# FINAL ENVIRONMENTAL IMPACT REPORT FOR THE LOS ANGELES AERIAL RAPID TRANSIT PROJECT LOS ANGELES, CALIFORNIA

December 2023

Los Angeles County Metropolitan Transportation Authority

Kimley-Horn

Figure 1: Traffic simulation results by the hour

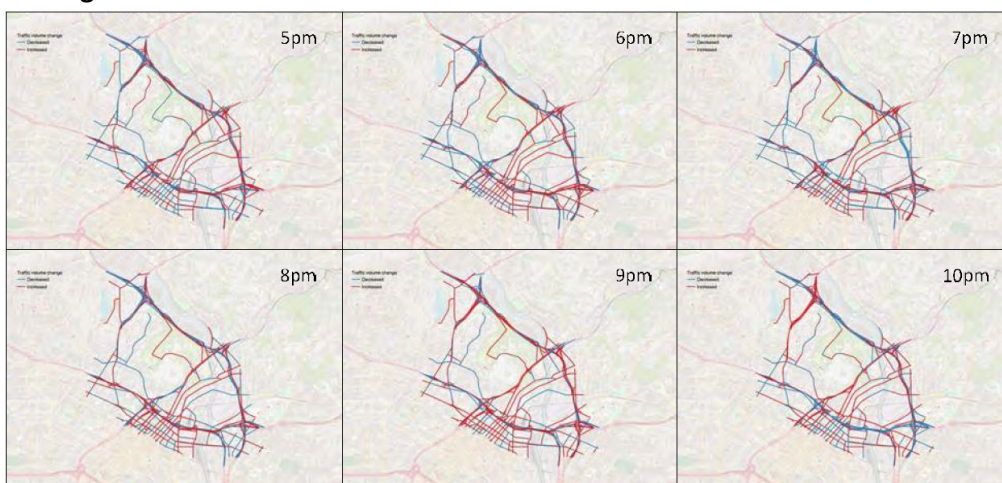
- Contrary to claims from LA ART, researchers found that the gondola would not significantly reduce traffic around Dodger Stadium.** Results showed the gondola would likely slightly reduce traffic on some roads around the stadium for a sold-out night game and increase traffic on others, leading to little reduction in greenhouse gas emissions. The red lines in Figure 1 above indicate road segments that have a higher traffic volume after the proposed gondola is added to the traffic simulation. The blue lines indicate a decrease in traffic volume. According to the simulation, the total traffic volume would likely be reduced by around 0.9%

The graphic presented in Figure 1 of the Mobility Lab Study illustrates preliminary traffic simulation results from the Mobility Lab’s model for the highway system in the vicinity of Dodger Stadium. The transportation model roadway network shown in Figure 1, however, shows that the Mobility Lab Study and model network is missing many of the critical roadways that link to Dodger Stadium (including Stadium Way, Vin Scully Avenue, Chavez Ravine Place, College Street, Bishops Road, the SR-110 ramps to/from the Dodger Stadium Downtown Gate, and the Dodger Stadium gates themselves). This is typical for regional travel demand models designed for analysis of the regional transportation system, which by design do not include smaller subregional streets or event venues. However, the missing streets play an important role in access to/from the stadium. A more sophisticated localized analysis of traffic increases and decreases in the vicinity of Dodger Stadium should include customization of the model’s highway network to include an increased granularity of detail for the streets serving the stadium, as this network has a profound effect on congestion in the neighborhoods surrounding the stadium. The lack of roadway network customization in the Mobility Lab Study model to include the key roadways serving Dodger Stadium underreports the benefits of trip reductions around Dodger Stadium, because the roadways that access the Stadium are those where the full benefit of the proposed Project would be experienced. The omissions of these roadways from the Mobility Lab Study model renders any estimation of traffic reductions and/or increases to be incomplete and aligns with the Mobility Lab’s own statement that their forecast for the proposed Project should be considered preliminary.

**Image from DEIR Appendix C – Visual Impact Analysis / Lighting Design**

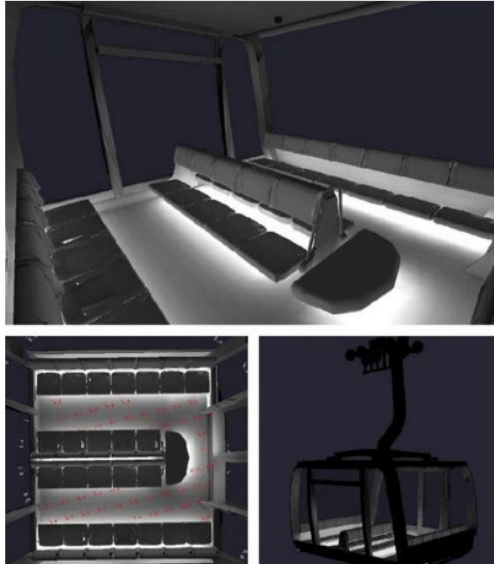
There needs to be greater consideration for security of the gondola infrastructure to prevent unintended uses of the system. If the opening of the Sixth Street Viaduct is any indication, the absence of ladders will not prevent people from climbing the towers and stations. If a person is able to get access to the Dodger Stadium parking lot or the Broadway Junction, would they be able to use The Gondola as a zip line?

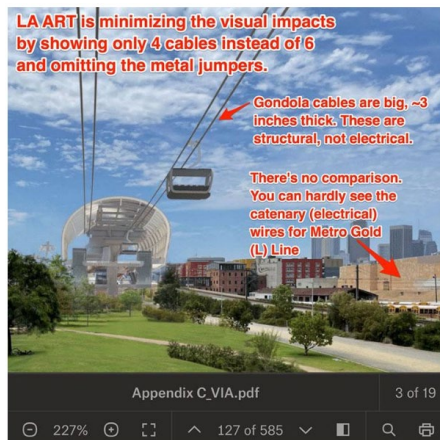
**Comment P702-51** LA ART claims The Gondola's cables over LA State Historic Park would not be significantly more impactful to views than the Gold Line's overhead catenary wires. We disagree. The Gondola cables are much thicker and hang directly over greenspace of the park.

**Response P702-51** As discussed in Section 2.0, Project Description, Section 3.16, Parks and Recreational Facilities, and Section 5.0, Other CEQA Considerations, of the Draft EIR, the proposed Project alignment crosses over the westernmost edge of the Los Angeles State Historic Park, adjacent to the existing Metro L Line (Gold) and the associated

overhead catenary system. Refer to Section 3.01, Aesthetics, and Appendix C, Visual Impact Assessment, of the Draft EIR, for discussion of the aesthetic impacts of the proposed Project, which would be less than significant. Refer to Appendix H.2, Supplemental KOPs in Response to Comments, for additional visual simulations of the proposed Project, including visual simulations to provide additional clarity regarding ropeway cable design for the gondola cabins. Refer to Section 5.0, Corrections and Additions, of the Final EIR, for an evaluation of the updated and additional KOPs for the proposed Project which would not result in significant impacts, and the aesthetic impacts of the proposed Project would remain less than significant. Refer to Appendix H.1, Memorandum Regarding Preparation of Key Observation Points, of this Final EIR, for a discussion of how the view simulations were prepared, noting that while the ropes would be 1.75 to 2.5 inches in diameter, this size is too small to be visually detectable in many of the view simulation renderings, and accordingly the ropes were modeled with a 6-inch diameter so that they would be visible.

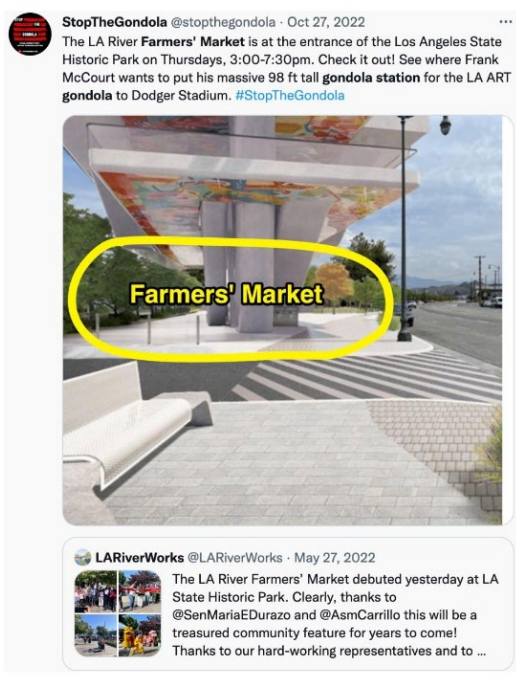
**Comment P702-56** The visual impact of the large gondola station sitting in front of the southern/pedestrian entrance of the park seems out of place, unwelcoming, and intimidating. It seems like bad Feng Shui.

**Response P702-56** As discussed in Section 2.0, Project Description, of the Draft EIR, the Chinatown/State Park Station would be located adjacent to Spring Street in the southernmost portion of the Los Angeles State Historic Park. The southern portion of the station would be located on City ROW, while the northern portion of the station would be integrated into the southern boundary of the Los Angeles State Historic Park. Refer to Section 3.01, Aesthetics, and Appendix C, Visual Impact Assessment, of the Draft EIR, for discussion of the aesthetic impacts of the proposed Project, which would be less than significant. The aesthetic impact of the Chinatown/State Park Station is discussed as part of the discussion of Landscape Unit (LU) 3. The Chinatown/State Park Station would consist of a neutral light-tone gray color scheme that would provide visual

**DEIR Image of Broadway Junction with Notes**

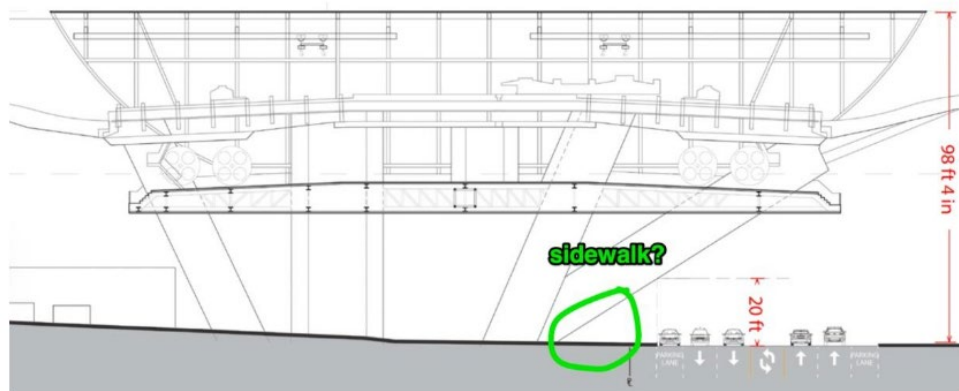
**Comment P702-89** Broadway Junction: More information is needed on the sidewalks around the Broadway Junction, especially at the area indicated in the image below. How high is the overhead clearance of the support column, how wide is the usable space of the sidewalk? There is a bust stop located at this location on Broadway. Will this interfere with a bust stop shelter? How wide will the sidewalk be along Bishop’s Road? Currently, there is no sidewalk, even though it is an official route to Dodger Stadium.

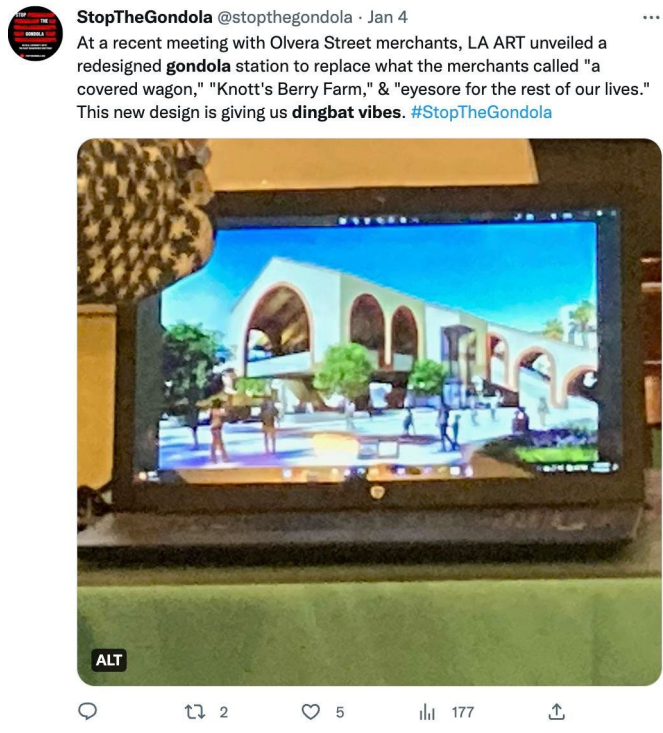
The "improved" station design that was recently presented to a group of El Pueblo merchants looks awkward, and like a dingbat, which is more of a mid-century style.
